DANE COUNTY DEPARTMENT of PUBLIC WORKS, HIGHWAY and TRANSPORTATION

RFB NO. 309030 - ADDENDUM NO. 2

PUBLIC SAFETY COMMUNICATIONS CENTER INFRASTRUCTURE UPGRADES

BID SET - ADDENDUM #2		
Dane Co Public Safety Comm Center Infrastructure Upgrades		
Madison, Wisconsin Co Bid No. 309030		ADDENDUM 2
		12/30/09
		REF. SHEET TT11
		T/SD-3

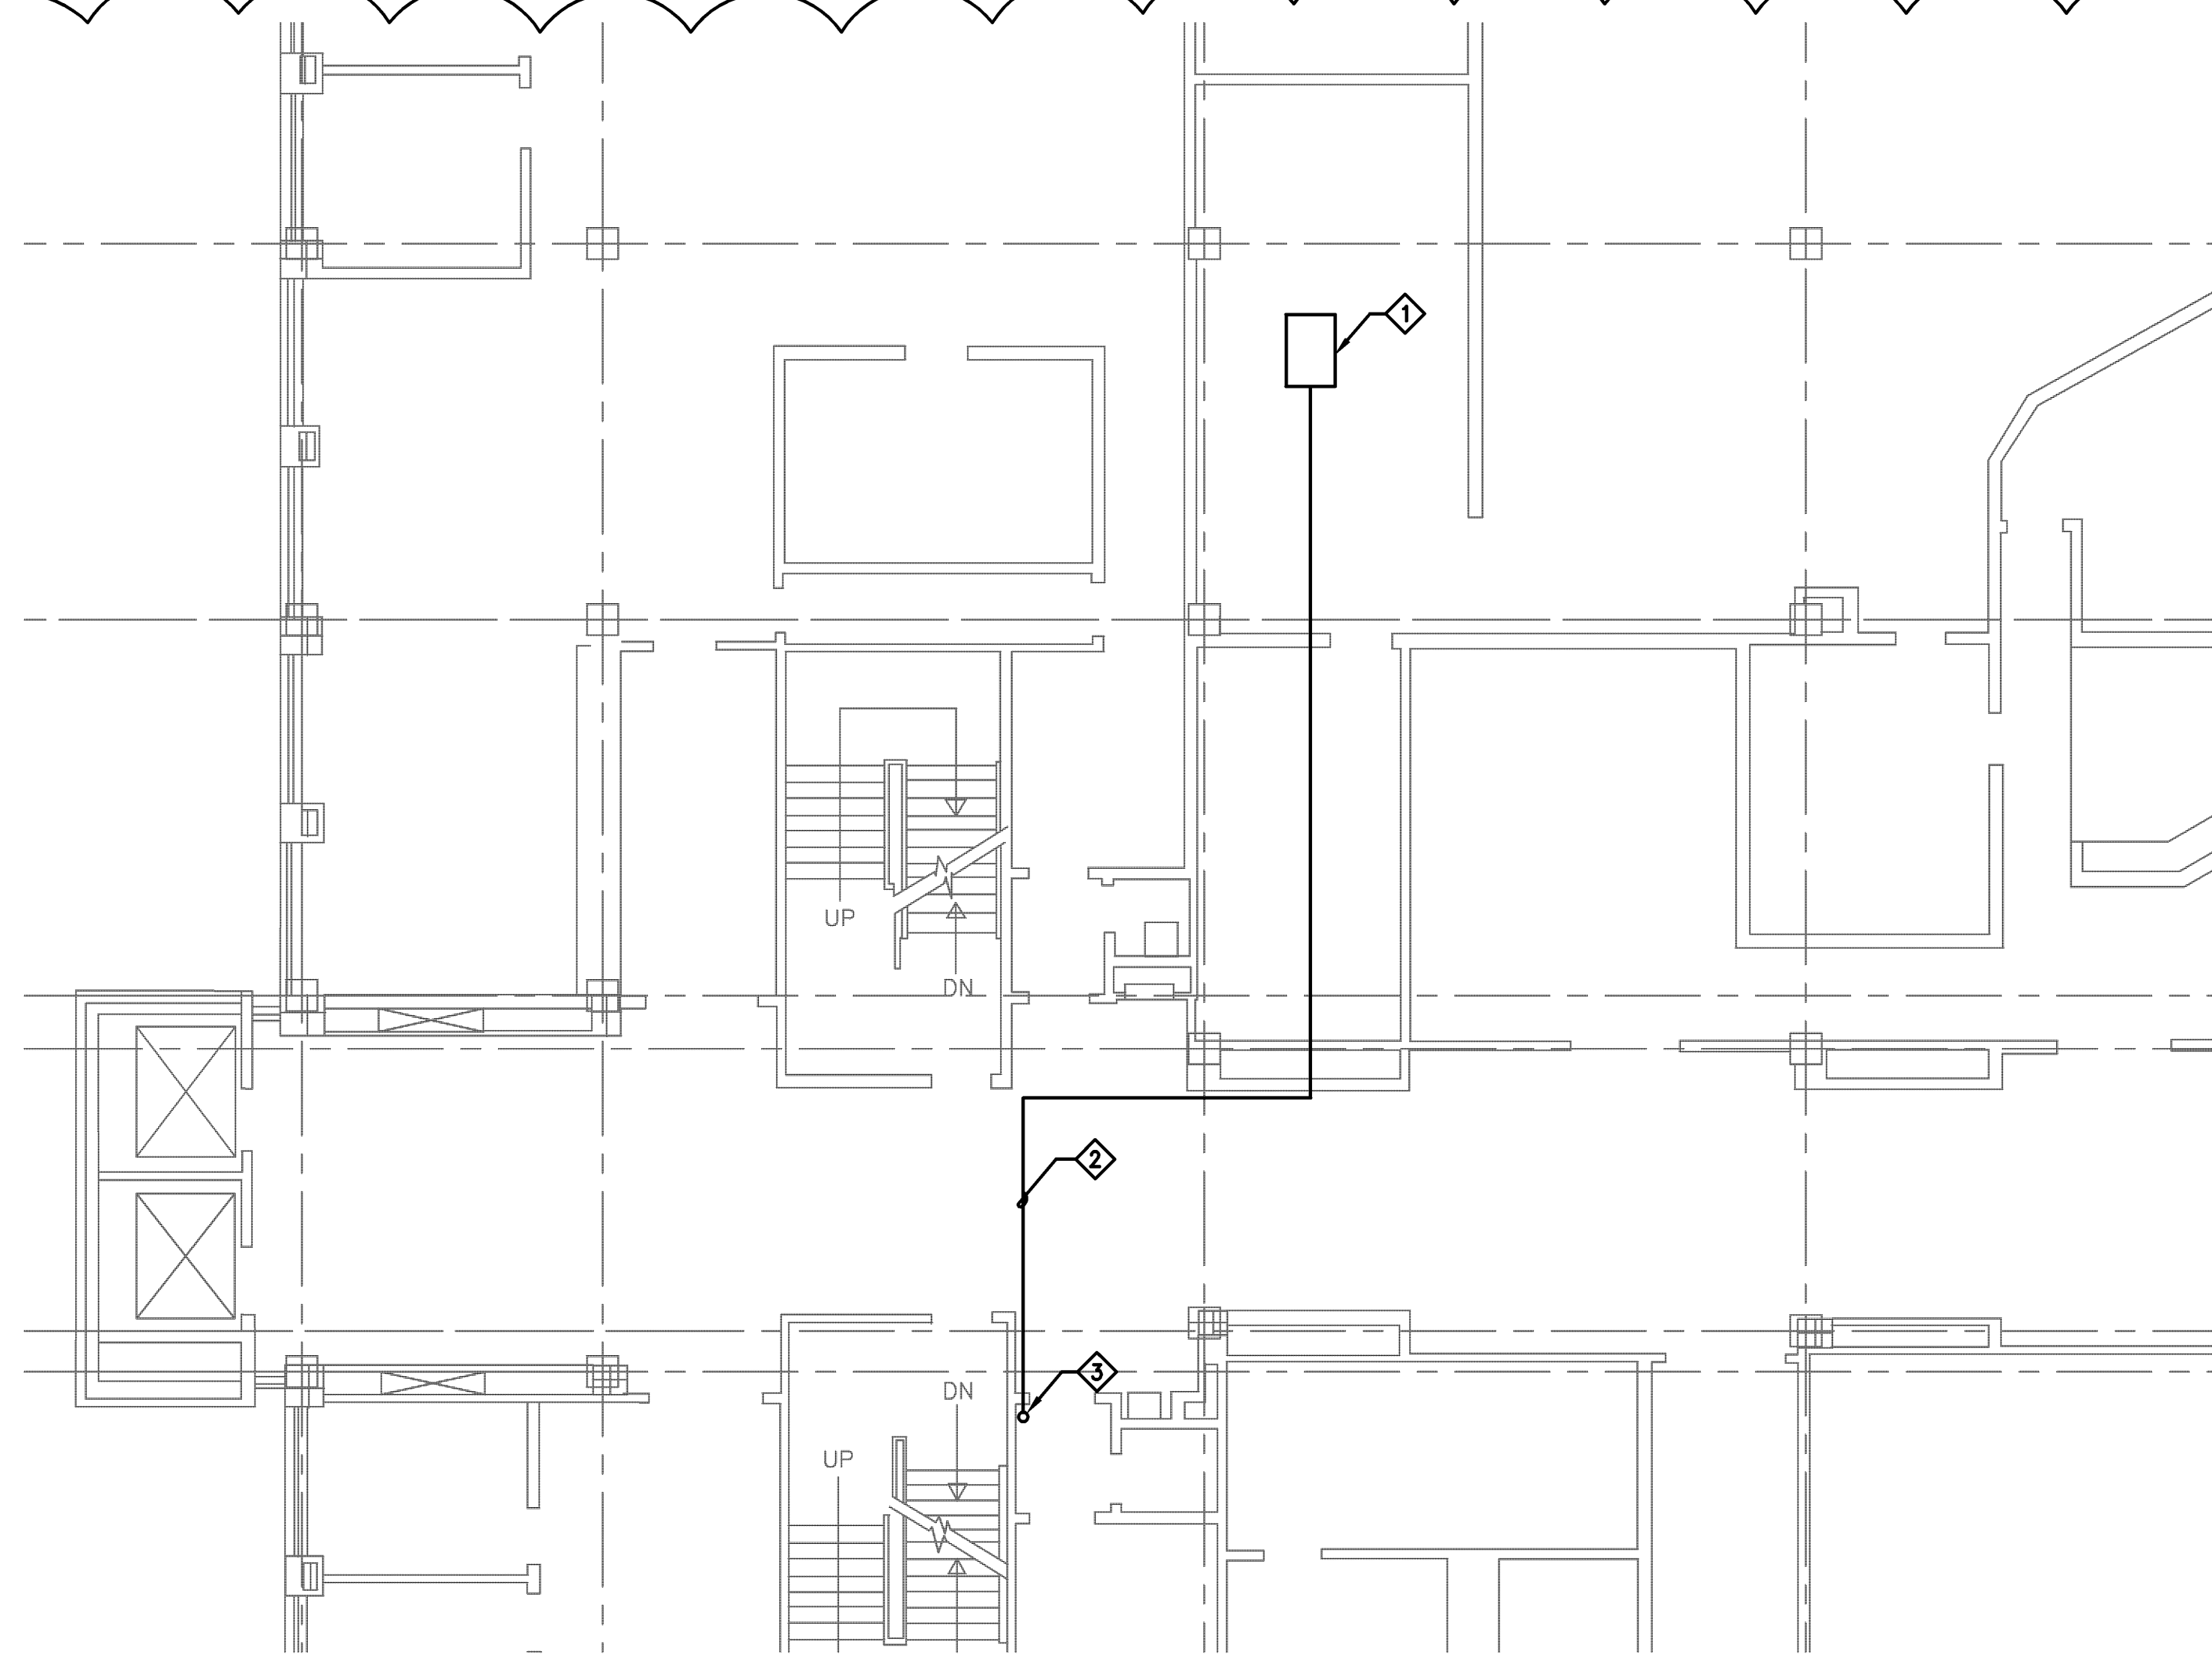
- 14) Sheet T2.2
 - a) ADD entire drawing attached.
- 15) Sheet T2.1
 - a) REVISE detail C/T2.1, detail note 6 to read as shown on attached drawing T/SD-1.
 - b) ADD plan note 13 to detail A/T2.1 as shown on attached drawing T/SD-2.
- 16) Sheet TT1.1
 - a) ADD plan note 25 to detail A/TT1.1 as shown on attached drawing T/SD-3.

25 OUTLET WITH 2 NETWORK DATA JACKS FOR 911 QUEUE BOARD. VERIFY MOUNTING HEIGHT W/OWNER BEFORE ROUGH-IN.

REF. SHEET PD2.1
 P/SD-2

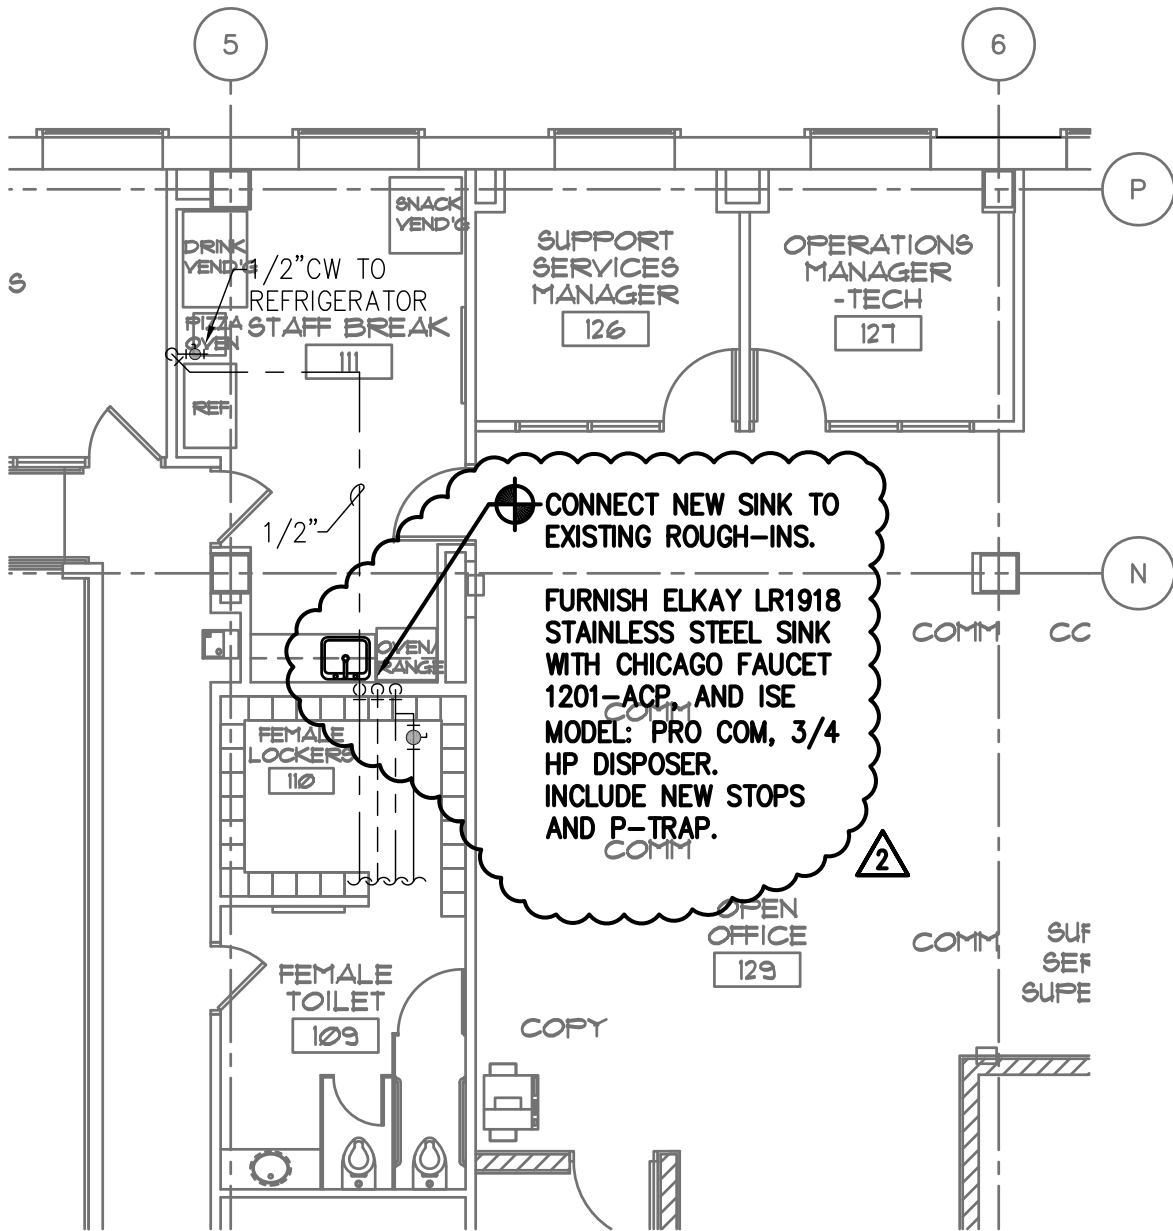
- 17) Sheet PD2.1
 - a) Drawing B; Demolition Plan - Plumbing

REVISE drawing per attached drawing P/SD-2 for change to existing sink to be demolished.
